THREE PHASE  
O/U VOLTAGE  
O/U FREQUENCY  
MICROPROCESSOR  
RELAY

**MC3V**

Addendum

Connection on 2 PT

**Wiring Diagram (Connection on 2 PT)**

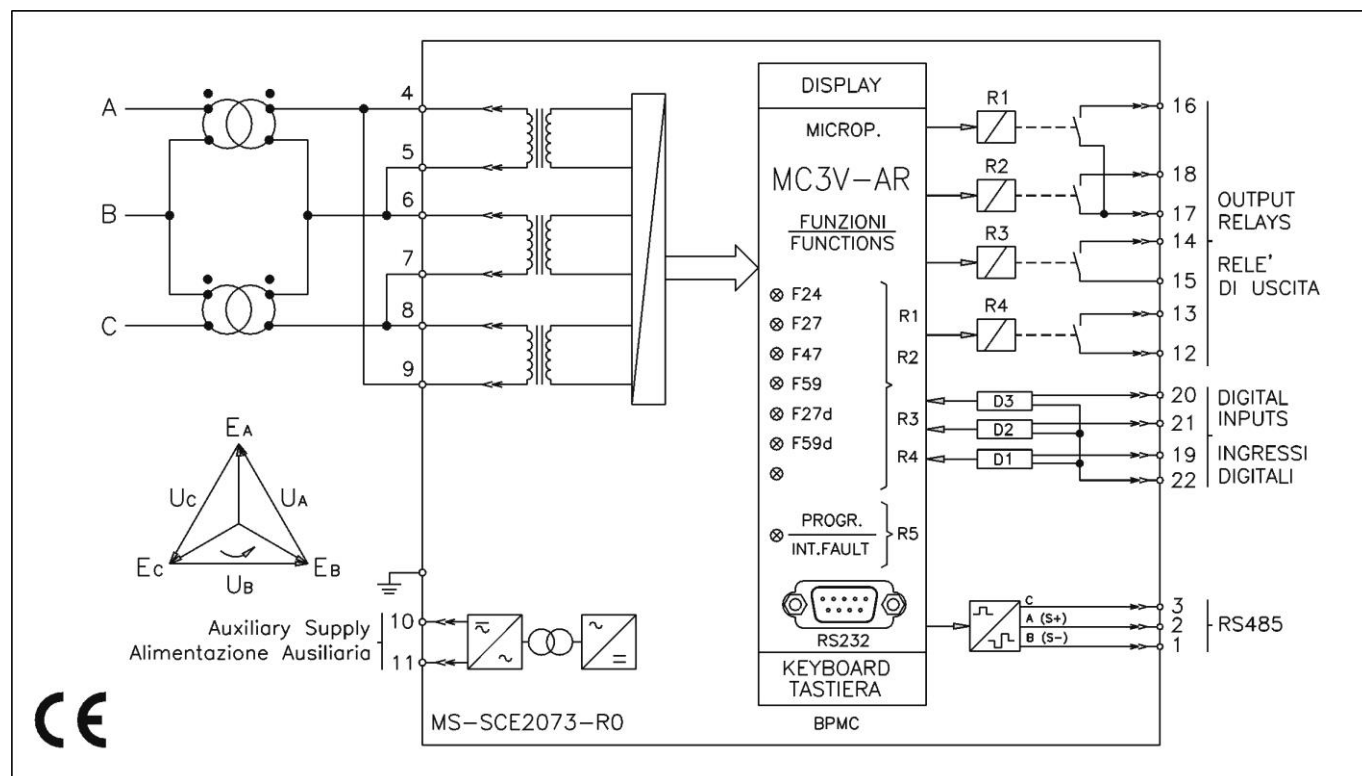
With this connection, the secondary rated voltage of the PT (see wiring diagram) must be set at the rated phase-to-phase voltage multiplied by 1.73.

Ex.: PT 1000/100

$V1n = 1000$

$V2 = 173$

Notice that in this connection the set zero sequence voltage can not be measured therefore the “Uo>” element must be set to “Dis” (Disable).
